ITEM: 6.7	REPORT SUMMARY MINOR VARIANCE APPLICATION FILE NUMBER A127/24
------------------	--

MINOR VARIANCE APPLICATION FILE NUMBER A127/24

CITY WARD #:	1
APPLICANT:	Copper Kirby Developments Limited
AGENT:	Steven McIntyre (Malone Given Parsons Limited.)
PROPERTY:	11363 Highway 27, Vaughan
ZONING DESIGNATION:	See below.
VAUGHAN OFFICIAL PLAN (2010) DESIGNATION:	Vaughan Official Plan 2010 ("VOP 2010"): "Low-Rise Residential" by Volume 2, Section 13.47 - 11363 Regional Road 27 (OPA #47)
RELATED DEVELOPMENT APPLICATIONS:	OP.17.007, 19T-22V006 & Z.22.029
PURPOSE OF APPLICATION:	Relief from the Zoning By-law is being requested to permit a proposed retaining wall.

COPPER KIRBY PHASE 1
19T - 22V006

GRADING PLAN 2

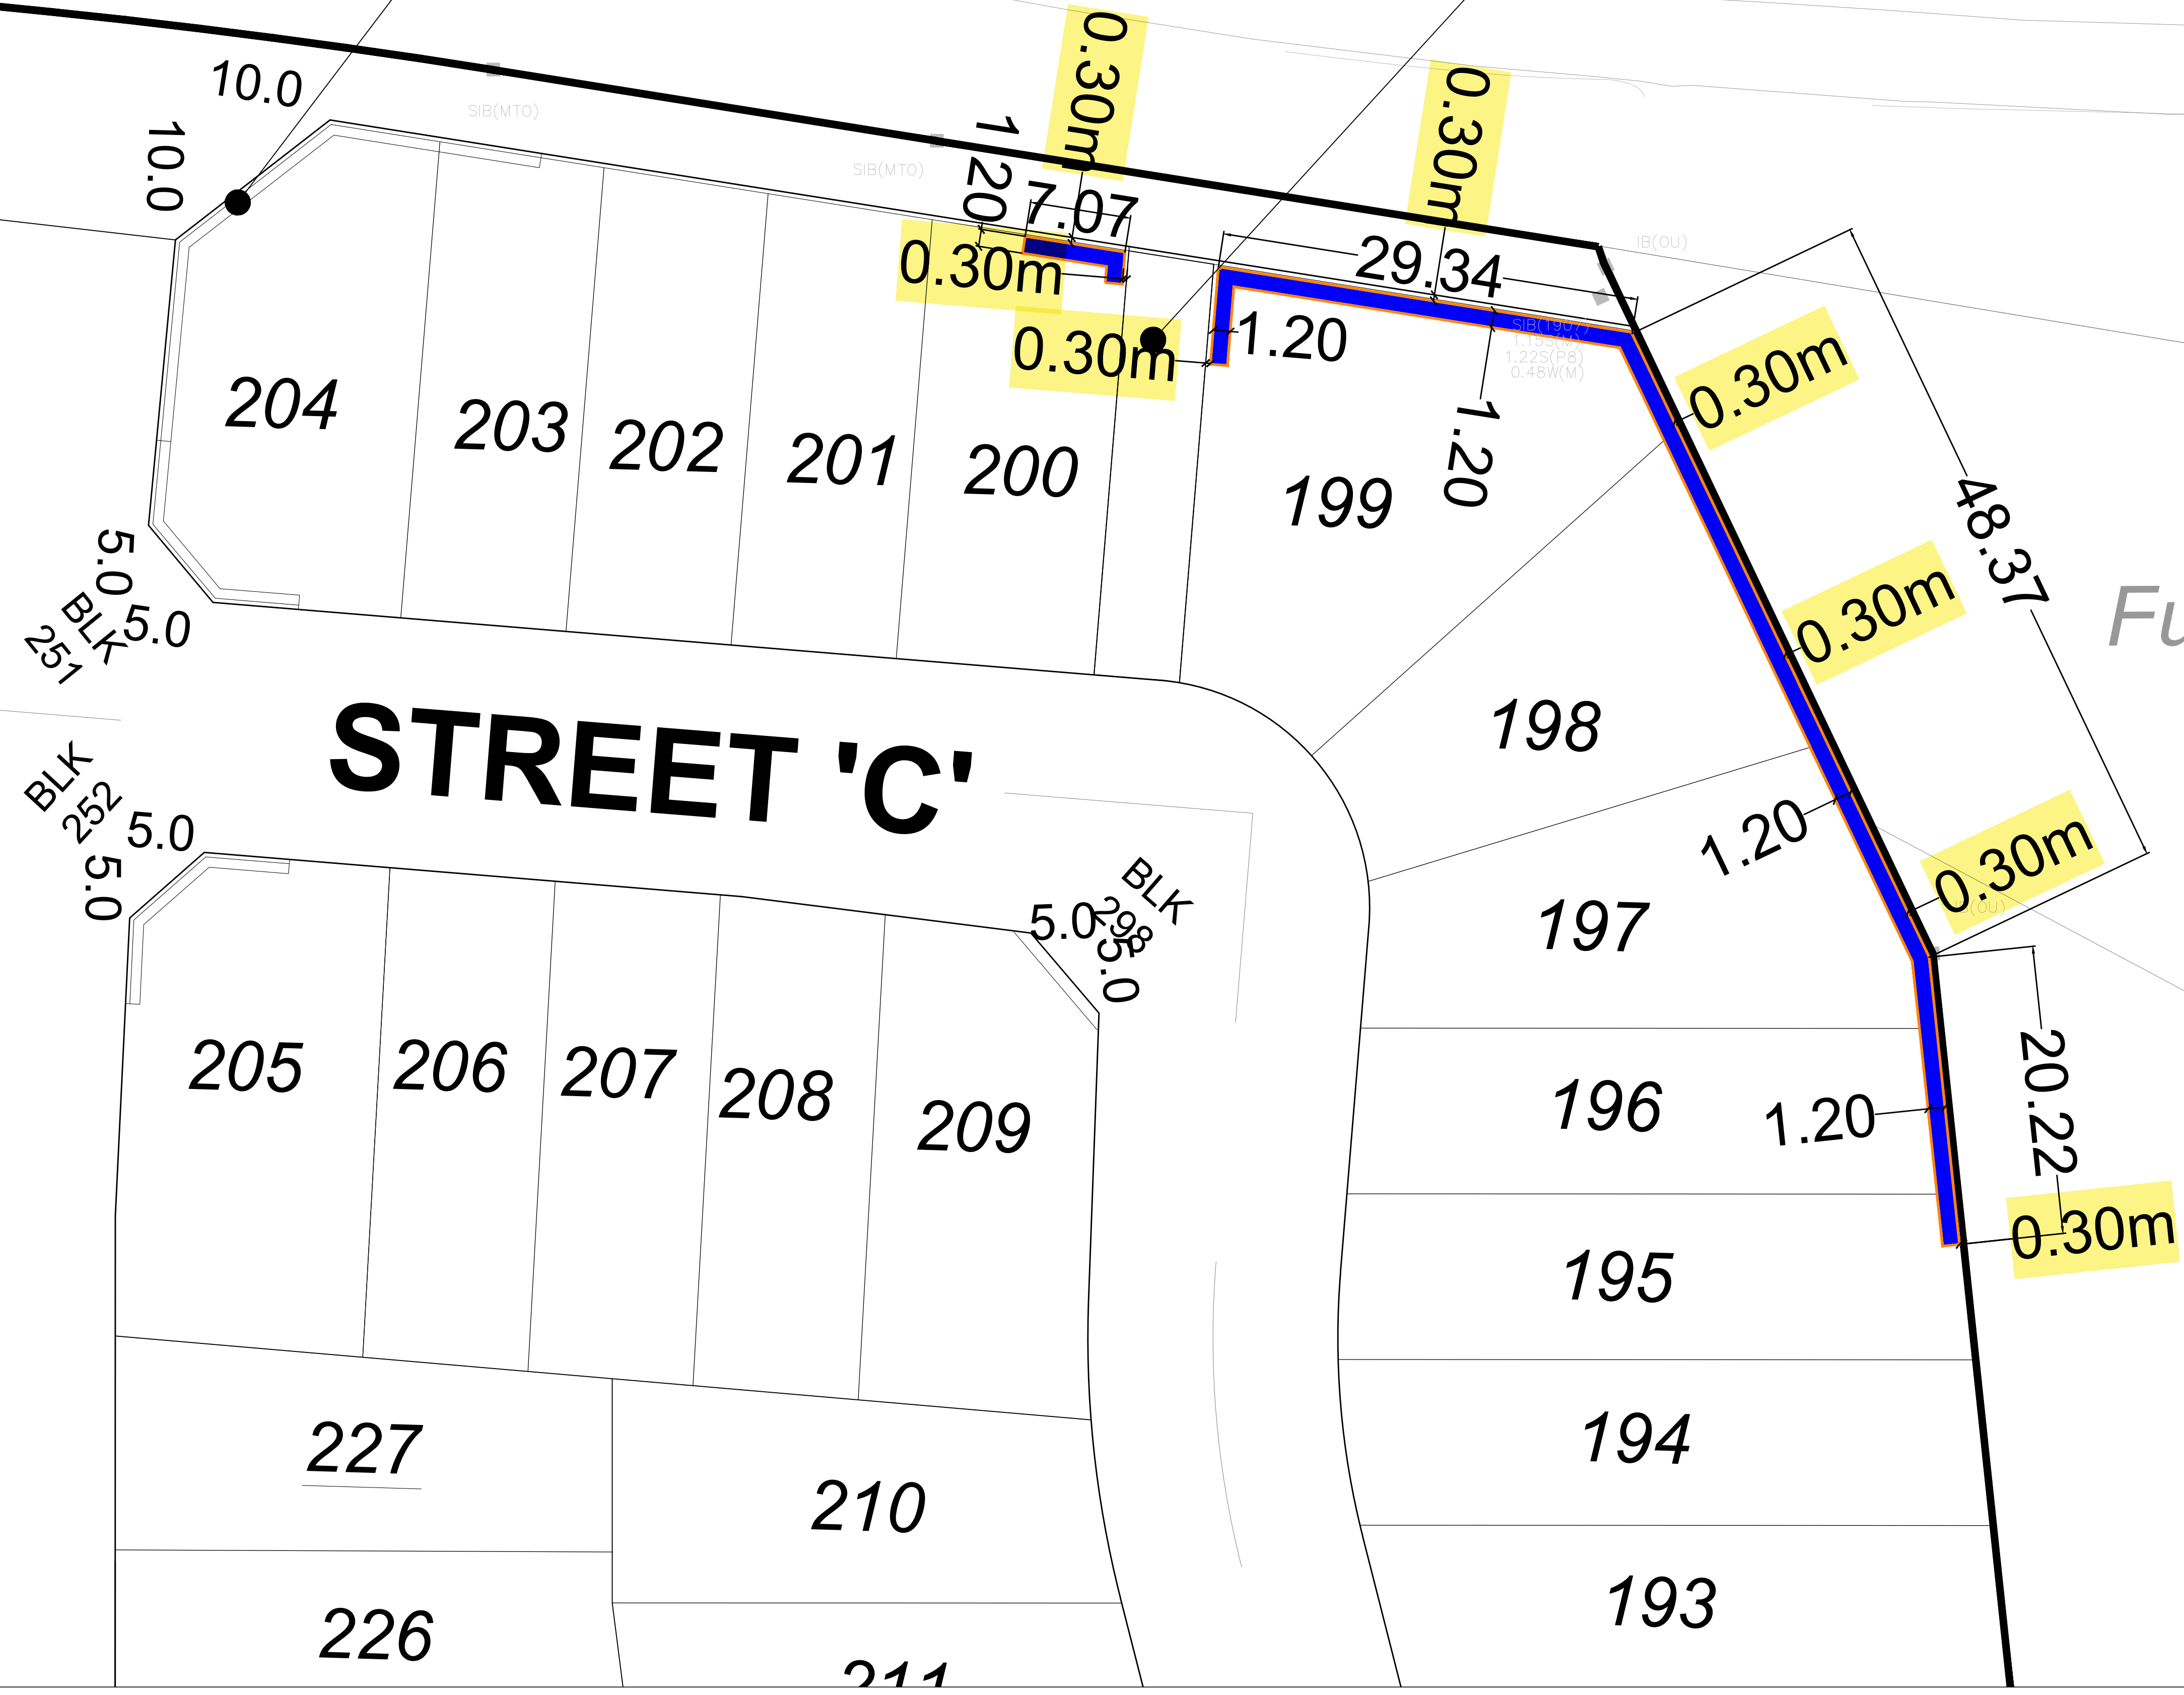
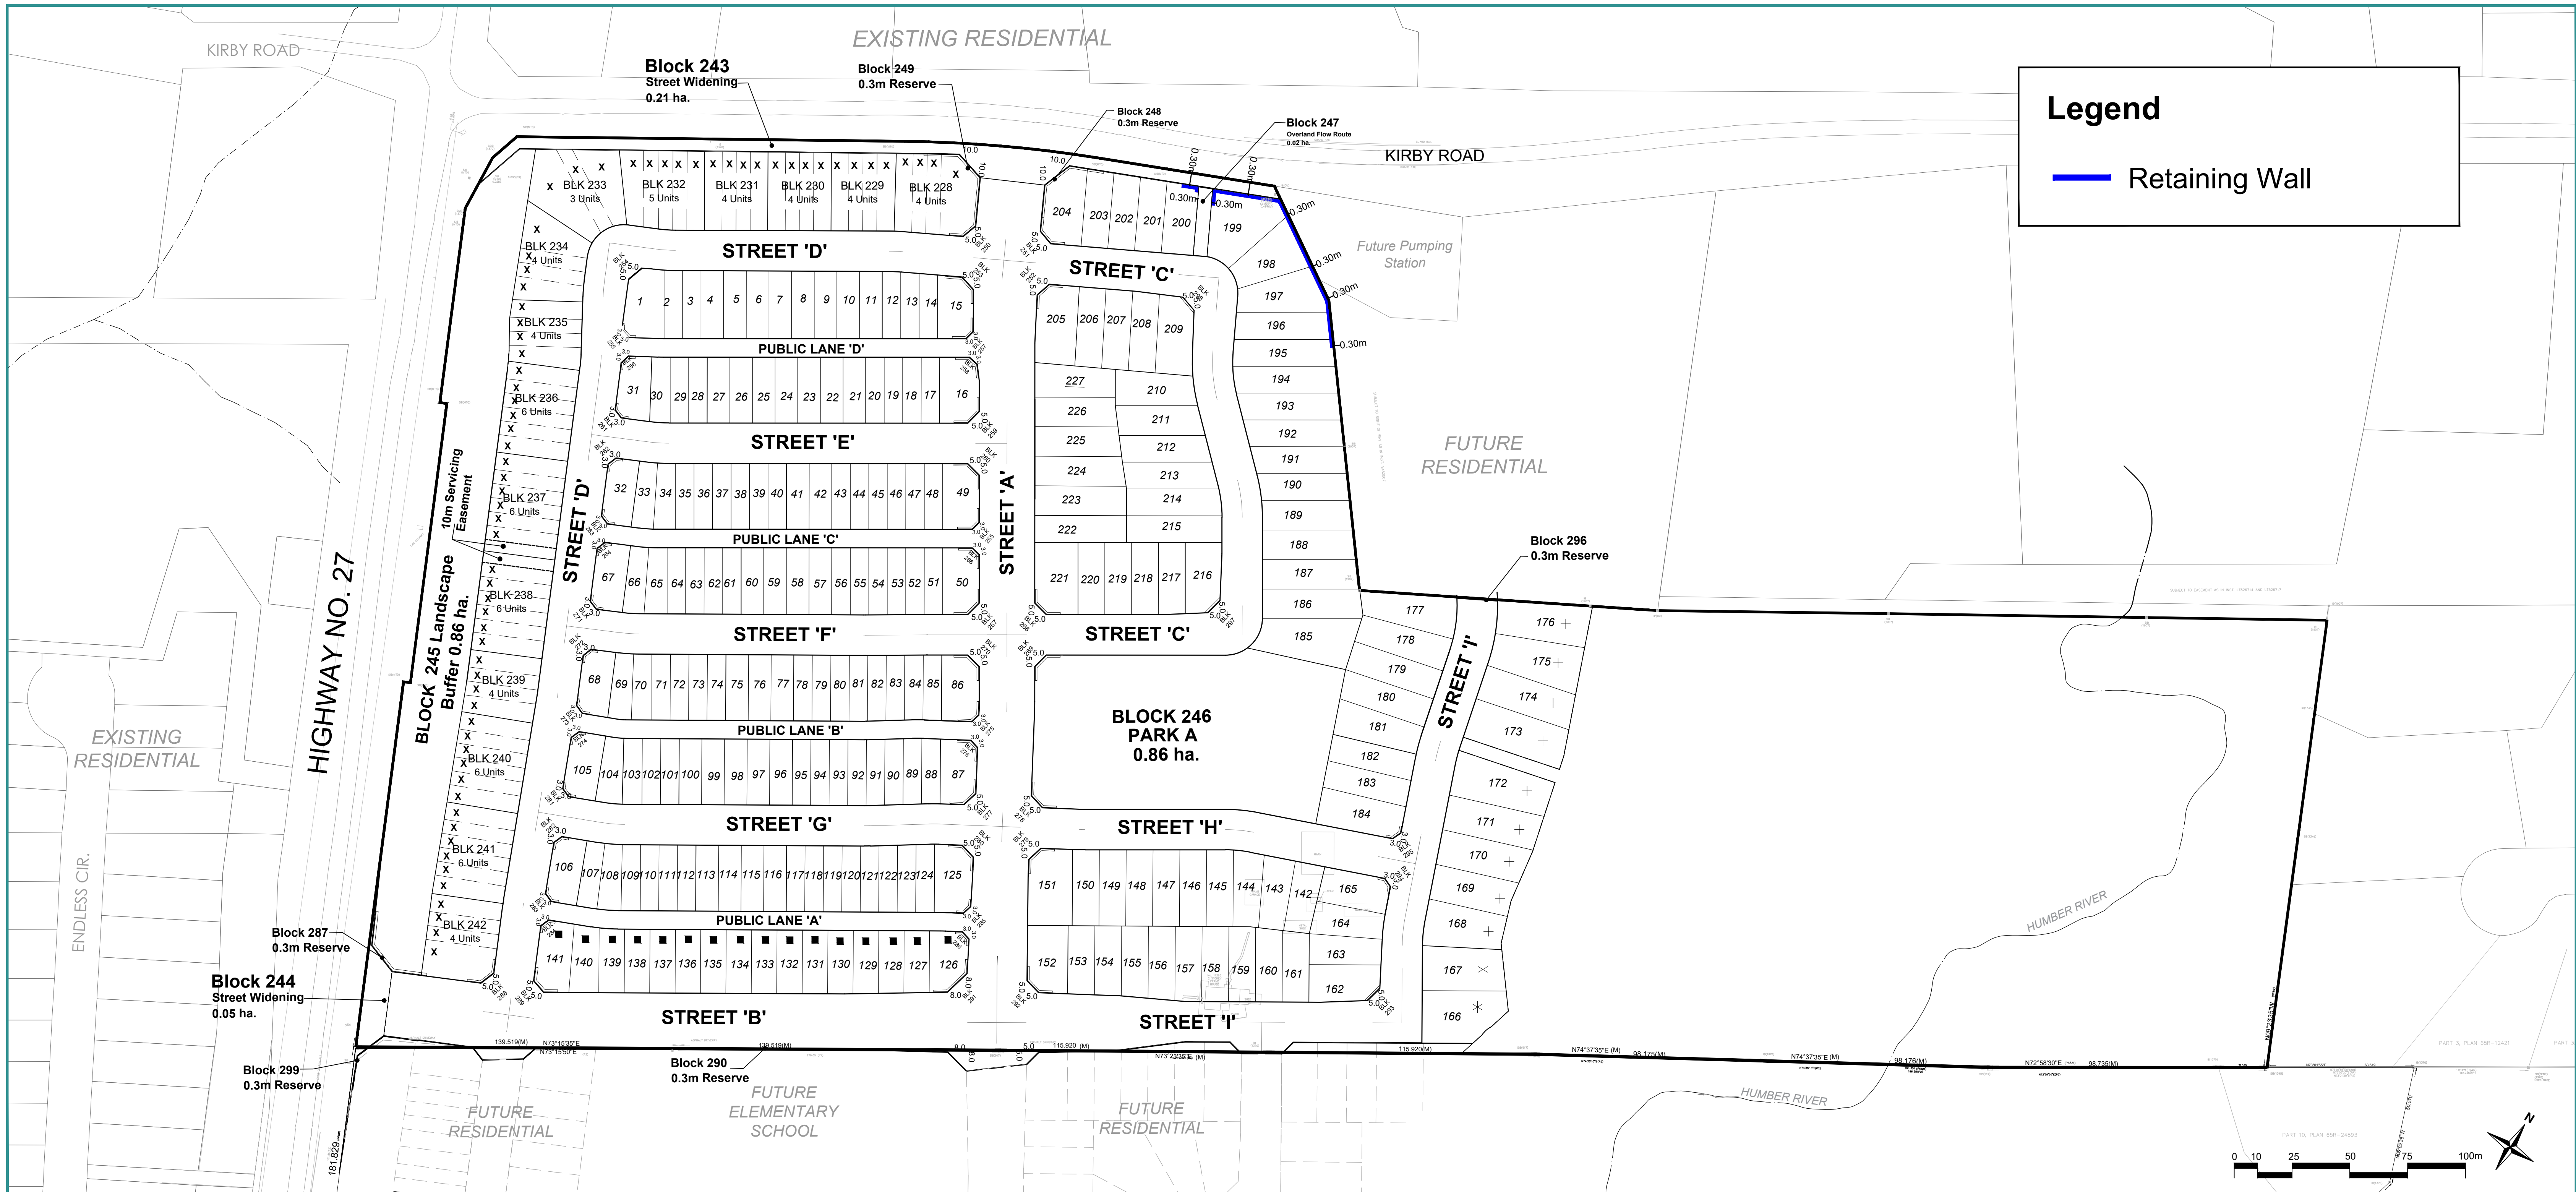
Development Engineering has reviewed application for the construction of the retaining wall and its encroachment to the temporary access to the existing dwelling where the sanitary pump station is proposed to be located. It is important that the timing of construction of the retaining wall is key so that it will not affect the disruption of the temporary access driveway. The Development Engineering Department does not object to the Minor Variance application A127/24, subject to the following condition(s):

Development Engineering Recommended Conditions of Approval:	The retaining wall shall not be constructed until an alternative access to the existing house has been provided, to the satisfaction of the City. Once the alternate access road is completed, the Owner/Applicant must submit proof, i.e. as-built drawings, inspection report, verifying that the road has been constructed.
--	--
